SAGE HILL ESTATES

PRELIMINARY/FINAL

LAND USE SUMMARY

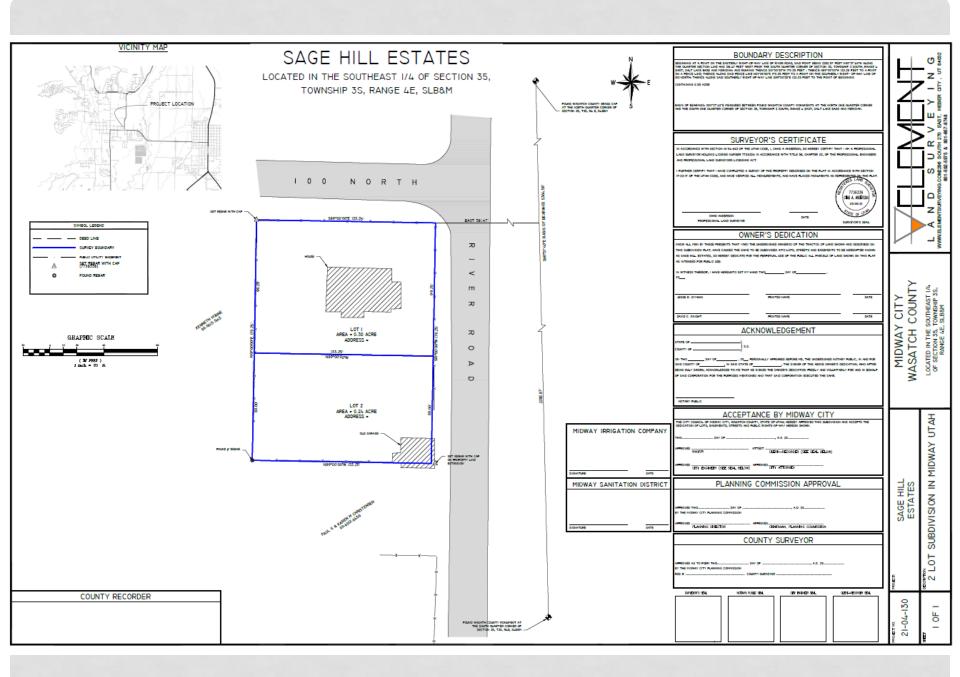
- 1. During the River Road reconstruction, the contractor installed water, sewer, and pressurized irrigation laterals to the proposed Lot 2 (City paid to avoid future road cuts). Prior to recording the plat, the owners shall reimburse the City for the cost of the laterals.

- 2. The owners shall dedicate the required areas for River Road and 100 North before recording the plat. River Road is local collector with a 66' ROW so the owners shall dedicate 33'. 100 North is a local road with a 56' ROW, so the owners shall dedicate 28'.

- 3. The existing, nonconforming garage on the premises shall be removed prior to the recording of any plat.
- 4. A note shall be included on the plat advising that only single-family dwellings are allowed on the two lots.

- 5. Access to Lot 1 shall be restricted to 100 North rather than River Rd.
- 6. Access to Lot 2, which fronts River Road, shall have a turn around so that cars are not backing onto River Road.
